Title		
WISP-6.0		
Size	Number	Revision
B		
Date:	11/04/2022	Sheet of
File:	Z:\wisp6\wisp-6-main.SchDoc	Drawn By:

Title Peripherals		
Size B	Number	Revision
Date: 11/04/2022	Sheet of	
File: Z:\wisp6\...wisp-6-peripherals.SchDoc	Drawn By:

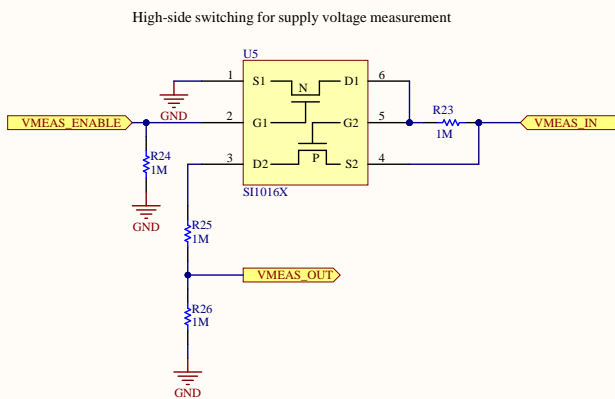
Changes:

- 1- C on VDD pin
- 2- ADDR to GND (unconnected is fine too)
- 3- VDD goes to MCU
- 4- SENSOR INT goes to MCU
